# Value Engineering Workshop Report

## US 41 - North Main Street Kentucky Transportation Cabinet

**Workshop Dates: August 16 - 20, 2021**

**September 3, 2021**

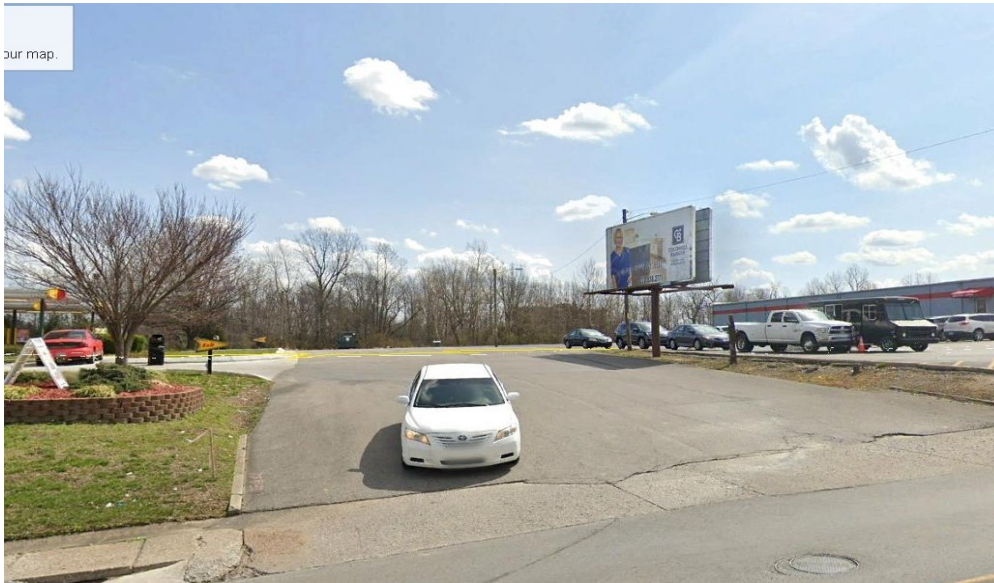
TITLE	Improve access management and pedestrian access using backage roads in the Southeast Quadrant						
DESIGN ELEMENT	BASELINE ASSUMPTION				PROPOSED ALTERNATIVE		
Description	Unit	Qty	Unit Cost \$	TOTAL \$	Qty	Unit Cost \$	TOTAL \$
Sidewalk	SY				1,245	\$ 53.21	\$ 66,246
Standard Header Curb	LF				2,242	\$ 30.00	\$ 67,260
<b>Pavement</b>							
Additional Right of Way							
CL3 ASPH Surf 0.5B PG64-22	Ton				226	\$ 86.08	\$ 19,454
CLS ASPH BAS 1.00D PF64-22	Ton				1,054	\$ 71.07	\$ 74,908
Crushed Stone Base	Ton				945	\$ 23.78	\$ 22,472
<b>TOTAL</b>				\$ -			\$ 250,000
<b>CWE (BASELINE LESS PROPOSED)</b>							\$ (250,000)

TITLE Manage US 41 direct access

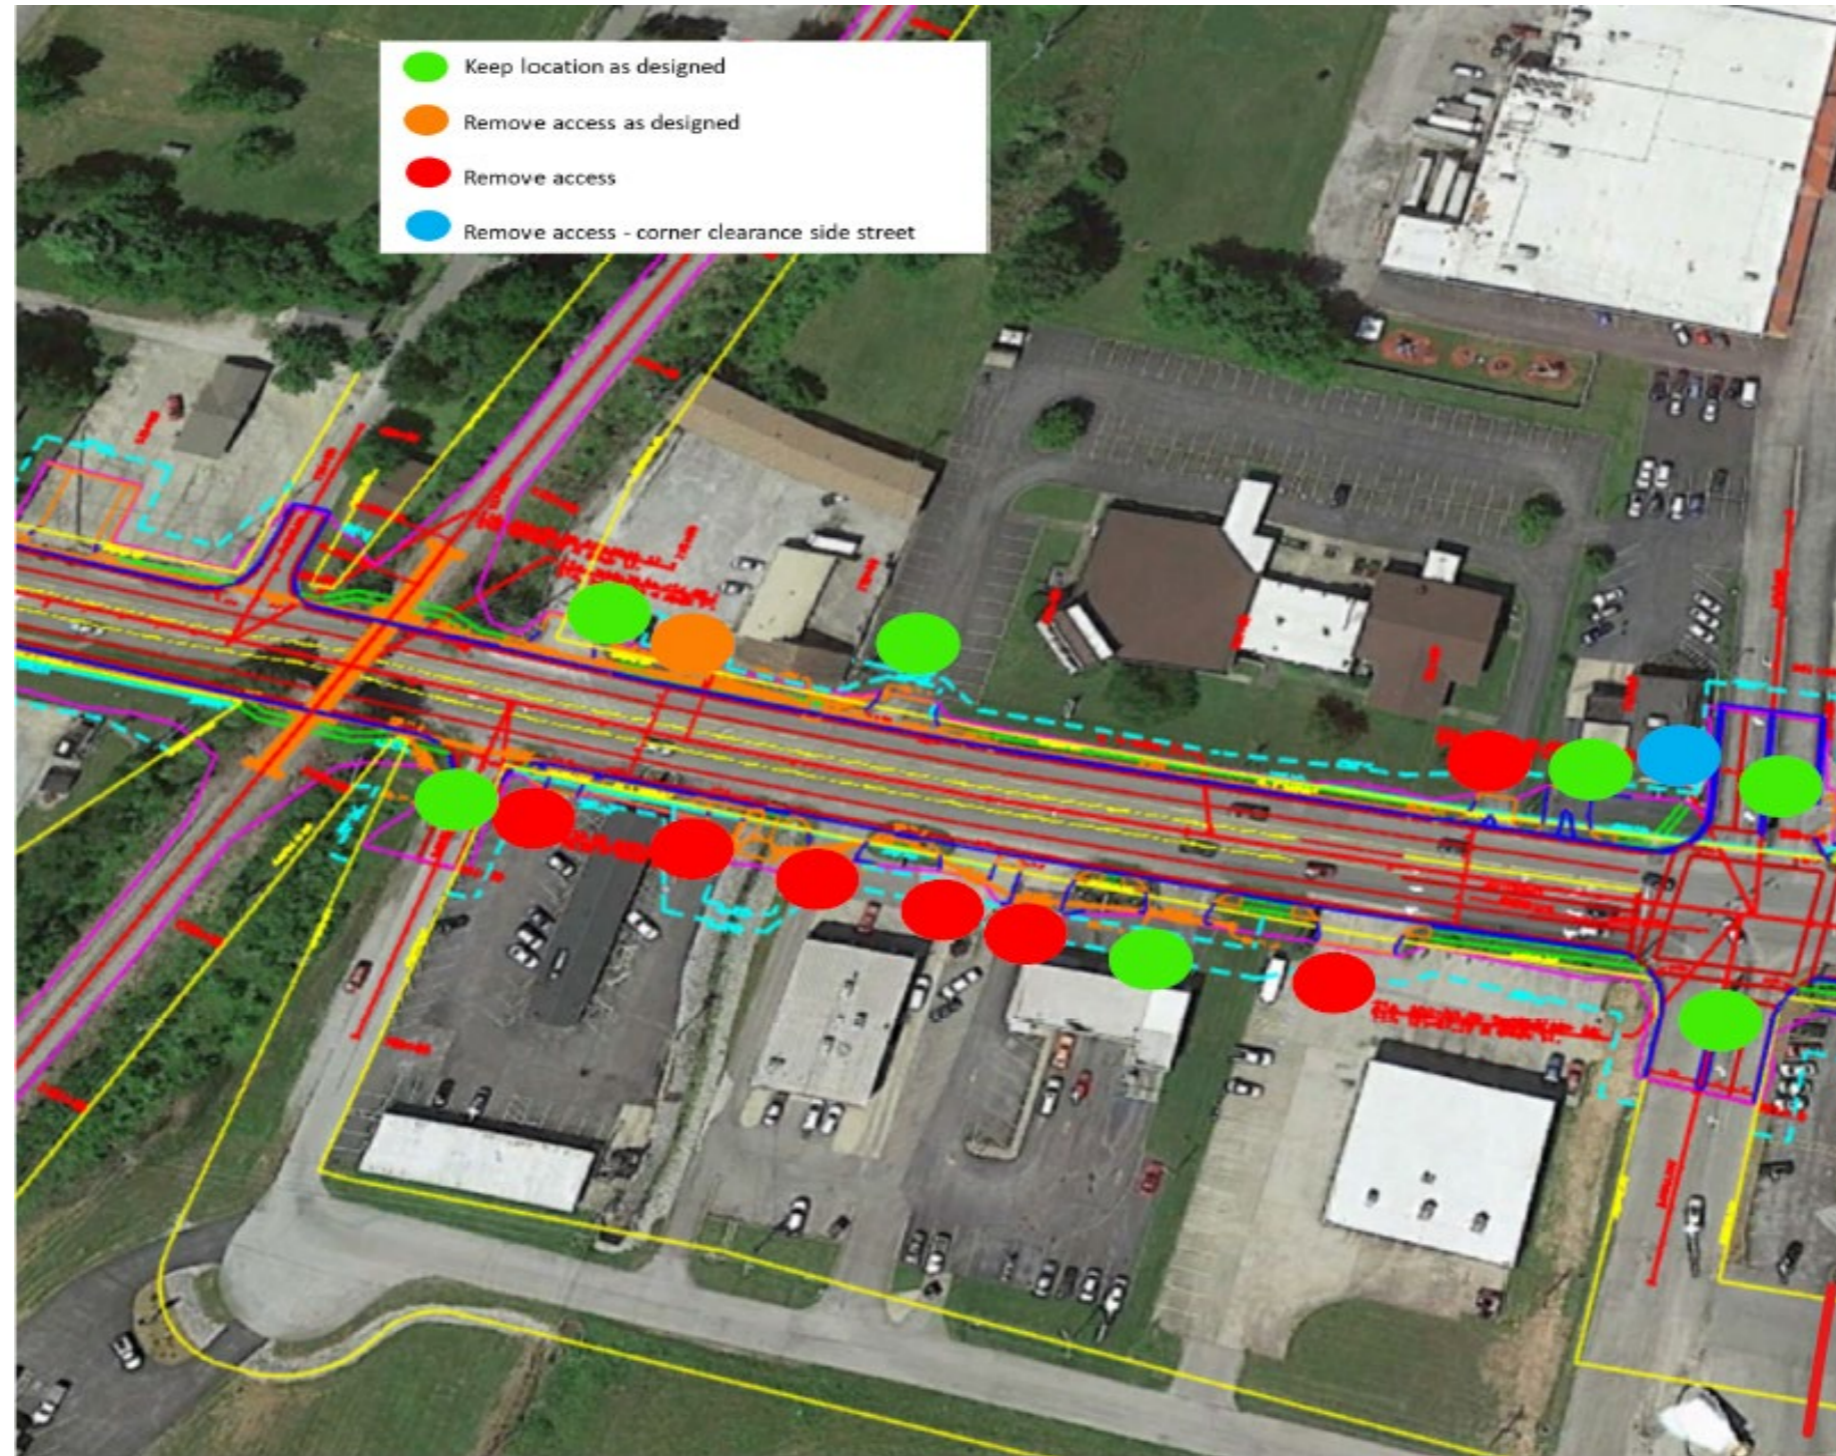
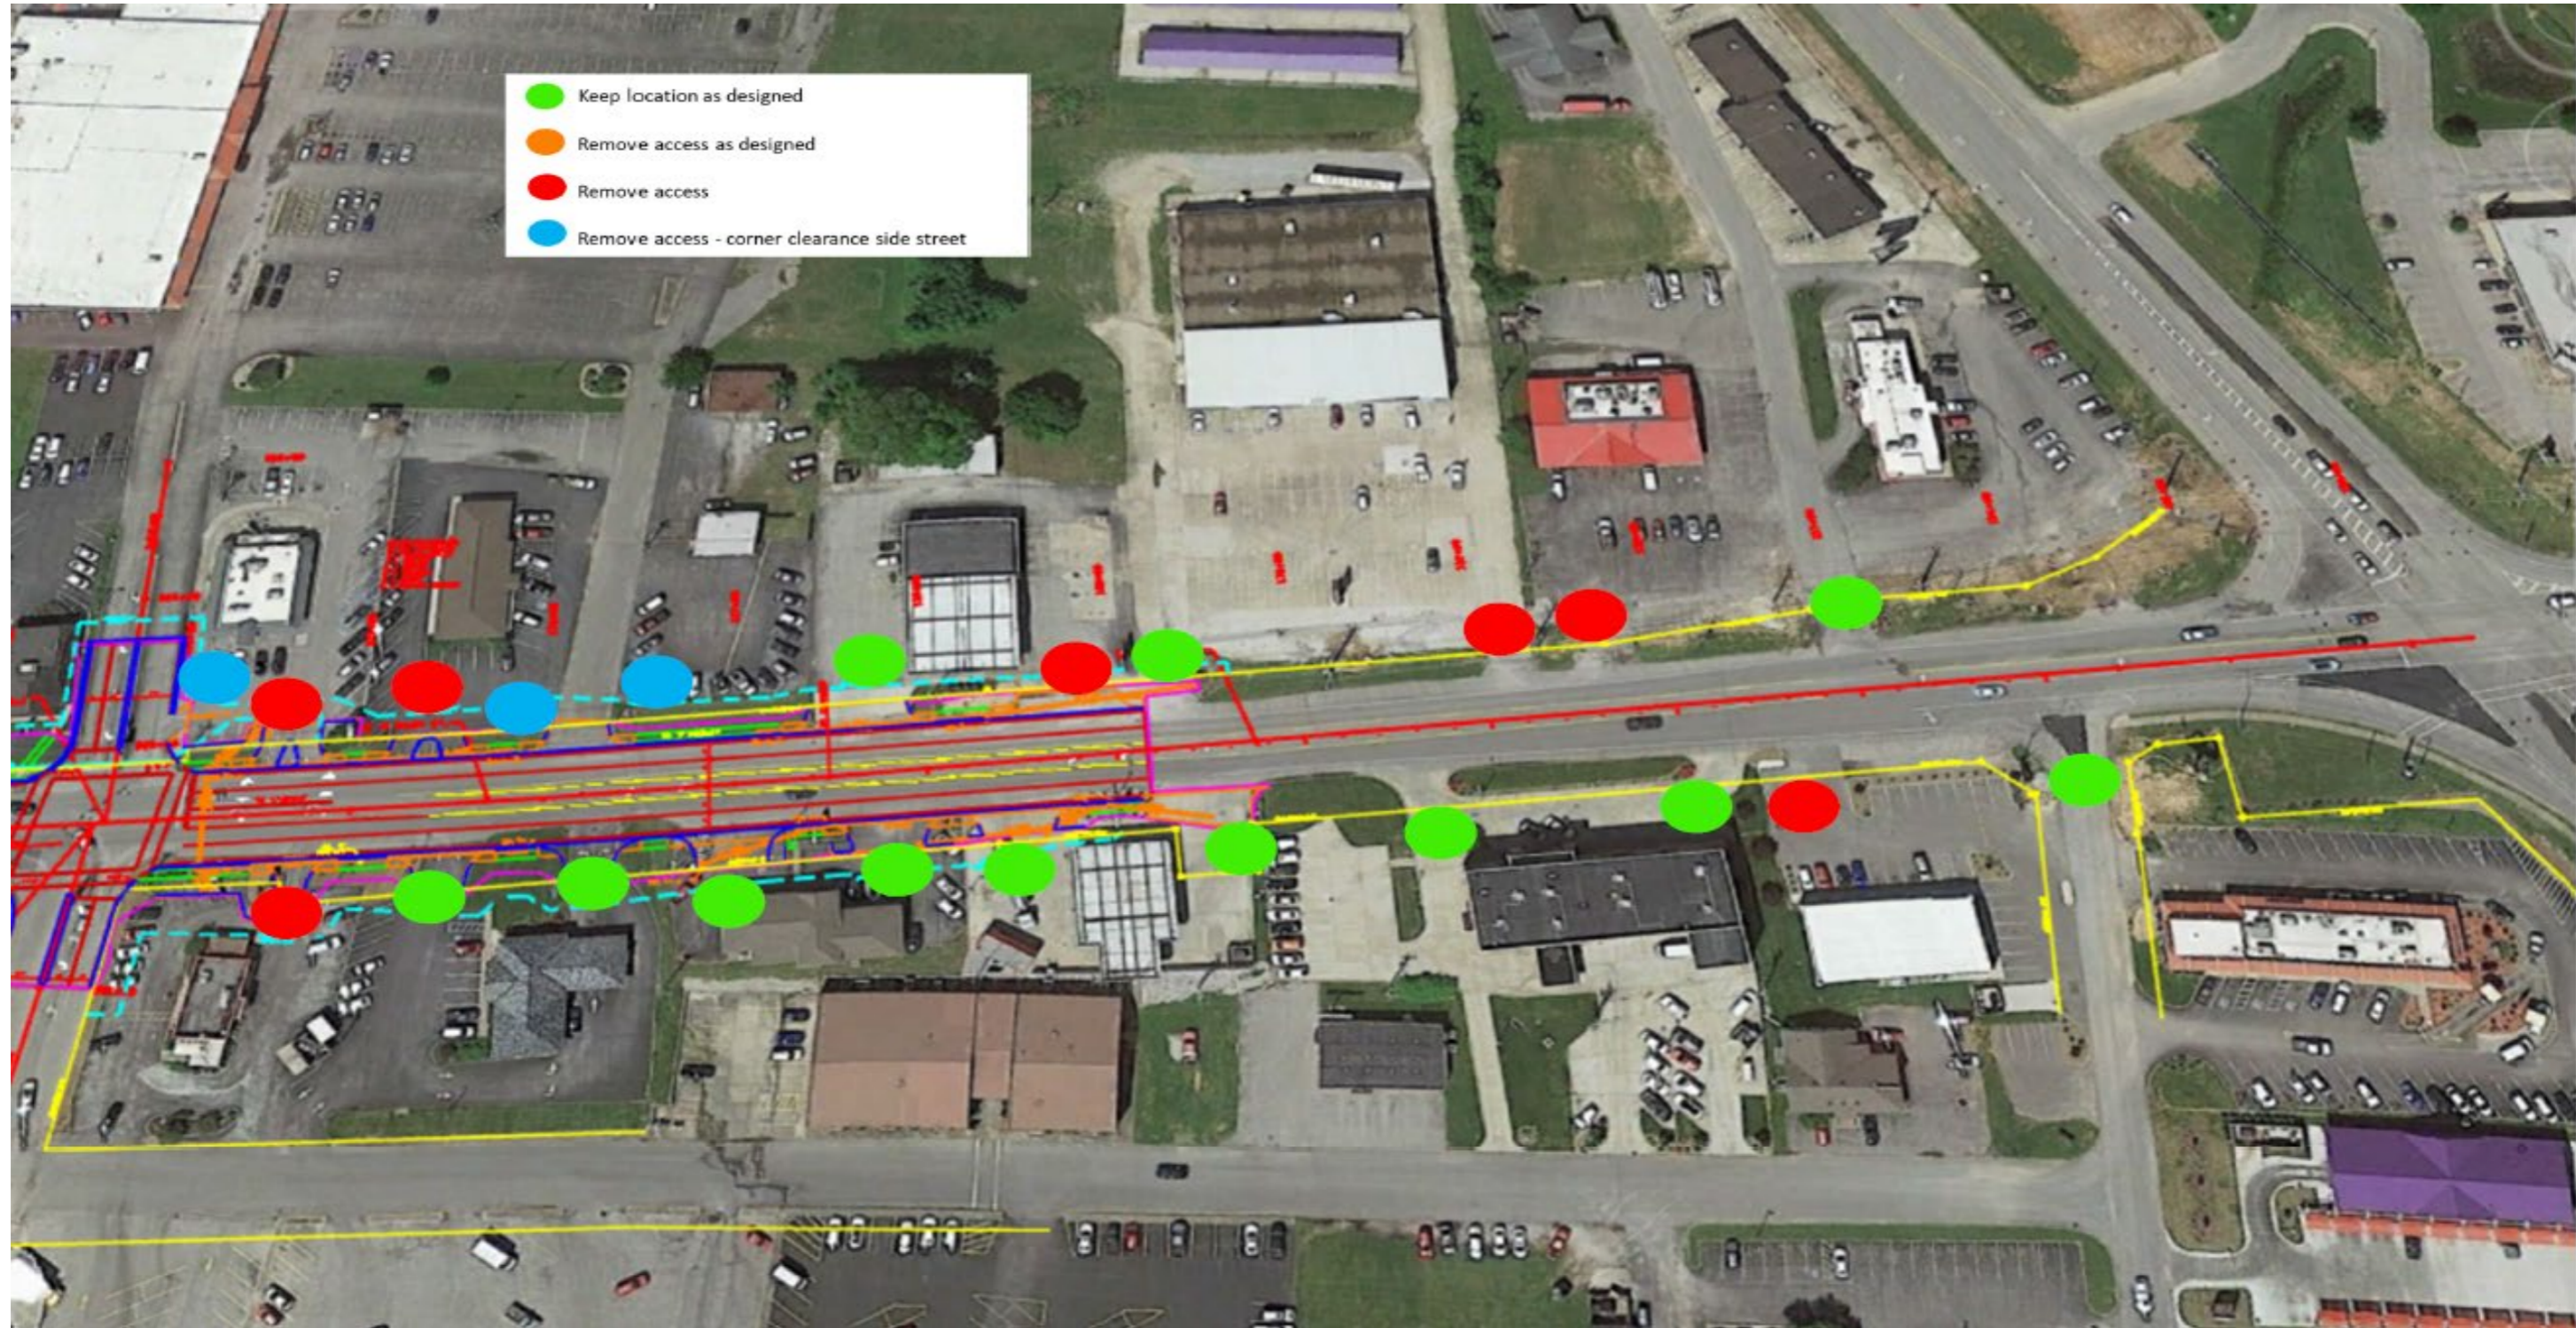
<b>TITLE</b>	Manage US 41 direct access		
<b>FUNCTION</b>			
<b>BASELINE ASSUMPTION:</b>			
In the baseline, Alternative 1, most of the current access points are left in the current location. A few have been removed or include a channelization island to encourage right-in/right-out only movement.			
<b>PROPOSED ALTERNATIVE:</b>			
This proposal suggest an opportunity to close redundant access points to US 41 that are duplicative or where there is sufficient access from the side or back of the property. This also ensures that the project provide adequate corner clearance both on US 41 and along side streets and entrances.			
<b>BENEFITS</b>		<b>RISKS/CHALLENGES</b>	
● Improves traffic flow		● Will add time and potential cost to Right of Way acquisition	
● Reduces conflict points, thus expected crashes		● Probable resistance by property owners whose access is modified	
● Better use of backage road system for access		●

Promote walkability on the mainline using Complete Streets (this will become a Design Suggestion)

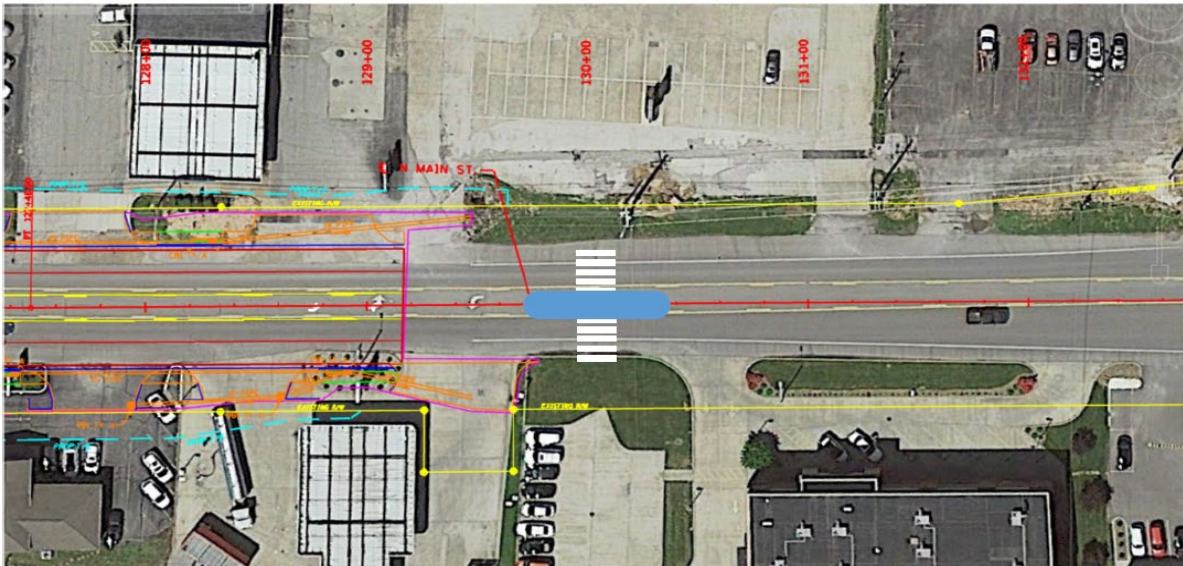
<b>TITLE</b>	Promote walkability on the mainline using Complete Streets (this will become a Design Suggestion)	
<b>FUNCTION</b>		
<b>BASELINE ASSUMPTION:</b>		
The current design calls for a 5-foot wide sidewalk offset from the travel lanes by a two-foot buffer.		
<b>PROPOSED ALTERNATIVE:</b>		
This proposes to widen the buffer strip, add street trees, provide adequate pedestrian crossings, and connect sidewalks to adjacent land uses along US 41.		
<b>BENEFITS</b>	<b>RISKS/CHALLENGES</b>	
● Higher pedestrian LOS (comfort level)	● Long term maintenance and future replacement of trees and landscaping must be considered	
● Separation of pedestrians from vehicles	●	
● Shade from trees to increase comfort	●	
● Visual beauty to the corridor and provides gateway entrance to city of Madisonville	●	
● Makes walking between businesses and other land uses more feasible	●	
● May increase attractiveness for redevelopment of adjacent and nearby properties	●

The baseline design recognizes the need to provide sidewalks along with a buffer strip along US 41. This recommendation, however, adds in a larger buffer strip (4 feet) and a planting strip (6 feet) with street trees to increase the comfort level of a pedestrian walking alongside traffic. NOTE: the additional planting strip and buffer width is under the assumption that the roadway footprint (number of lanes) is reduced and everything can be built within the current baseline 78-foot Right of Way width.

<b>TITLE</b>	Alternative 4 – (New Alternative) Two-lane roadway with two roundabouts
--------------	---

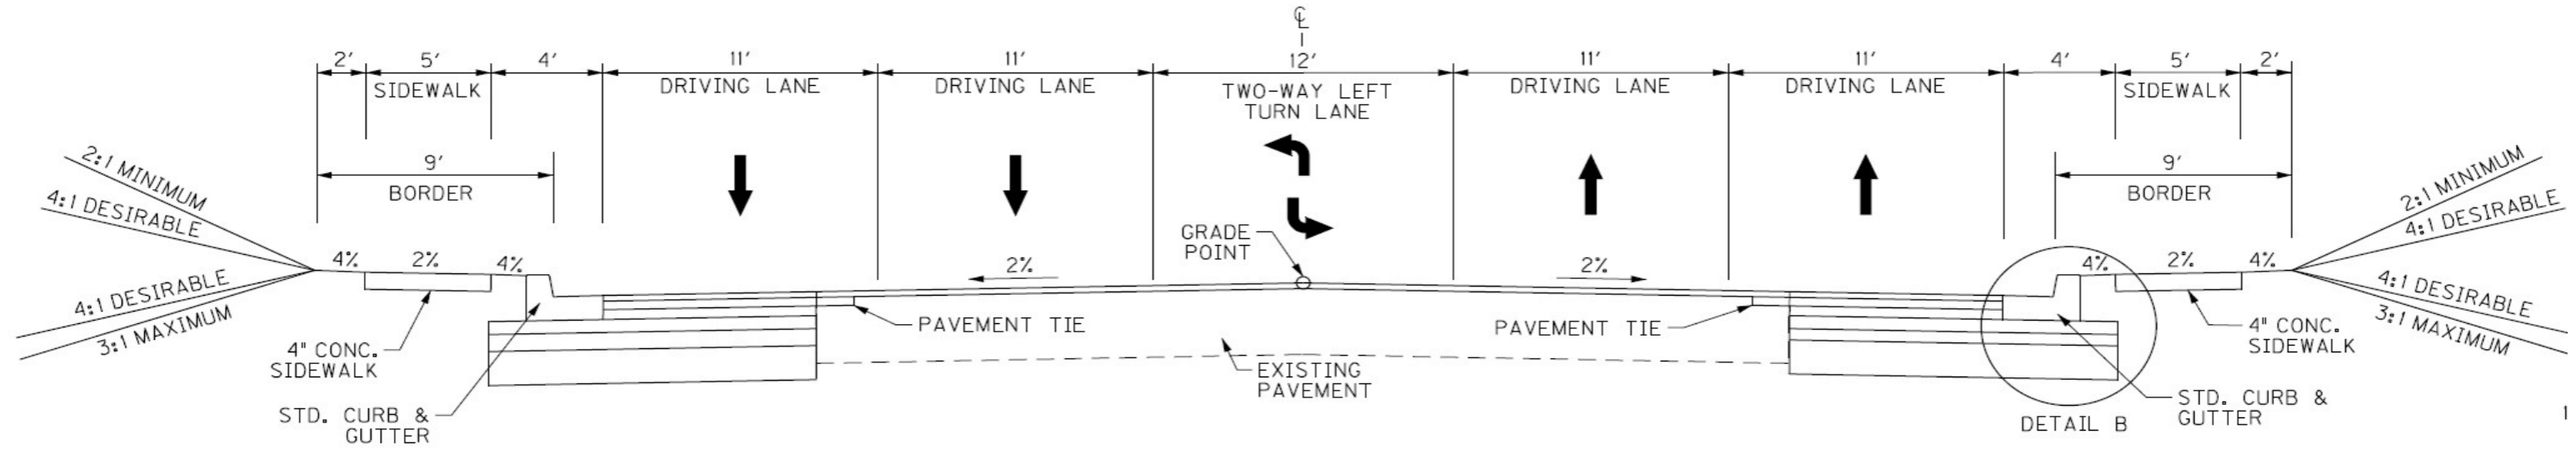
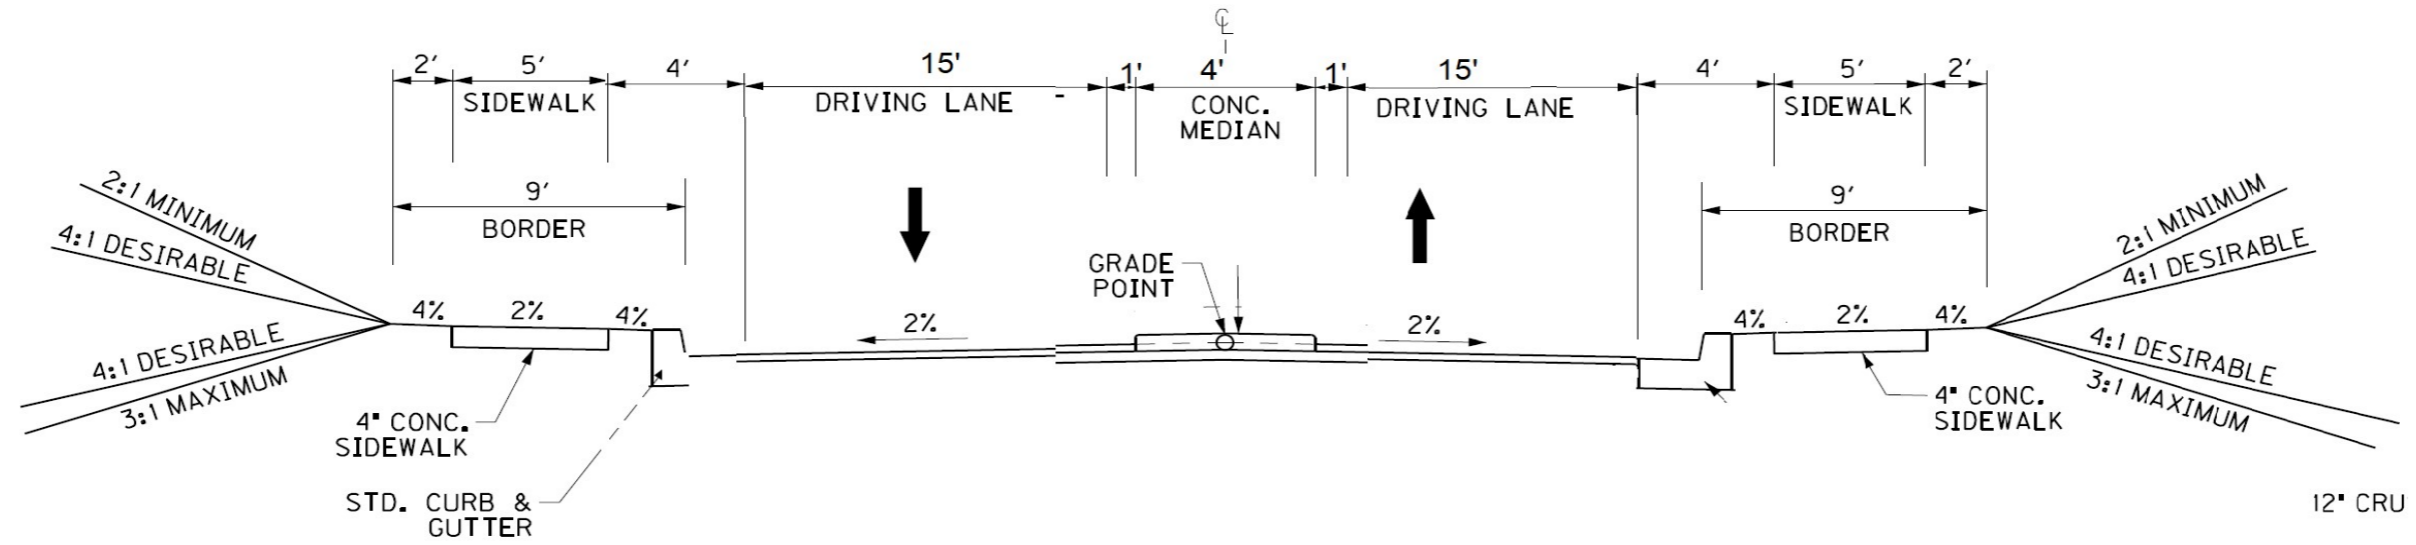
<b>TITLE</b>	Alternative 4 – (New Alternative) Two-lane roadway with two roundabouts
<b>DISCUSSION/JUSTIFICATION:</b>	
<p>Roundabouts provide a significant improvement in safety. Several studies show an over 90 percent reduction in severe injuries and the elimination of fatalities. The raised median will prohibit left turns at driveways. About 74% of access crashes are left turn maneuvers. Overall, Alternative 4 is expected to reduce total crashes by 37% and serious injury crashes by 49%.</p> <p>Single-lane roundabouts are safer than multi-lane roundabouts in terms of total crashes. (Based on current studies).</p> <p>Roundabout are more efficient for traffic. There is no signal related stop delay, which is currently the basis for the current back-up situation in the current condition, there is, however, some delay due to the yield at entry requirements. HCS shows the peak hour queues are slightly longer at the roundabouts for the Northbound and Southbound US 41. Roundabouts are much more efficient than signals during off-peak hours. (22 to 23 hours each day). Roundabouts should perform at LOS A during non-peak hours.</p> <p>Roundabouts can accommodate a larger design vehicle for U-turns and provides better turning radius for trucks. The loons proposed for Alternative 1 only accommodate passenger vehicles.</p> <p>The roundabout also relieves sight distance difficulties typical of left turn lanes with negative off-set.</p> <p>ICD diameter for single lane varies between 135 and 90 feet. 135 feet is used here to estimate the footprint.</p> <p>HCM shows the roundabouts outperform both Alternative 1 and current conditions in terms of both delays and queues.</p> <p>This also provides a level of traffic calming as the roundabout design speed will be about 15 -18 mph</p>
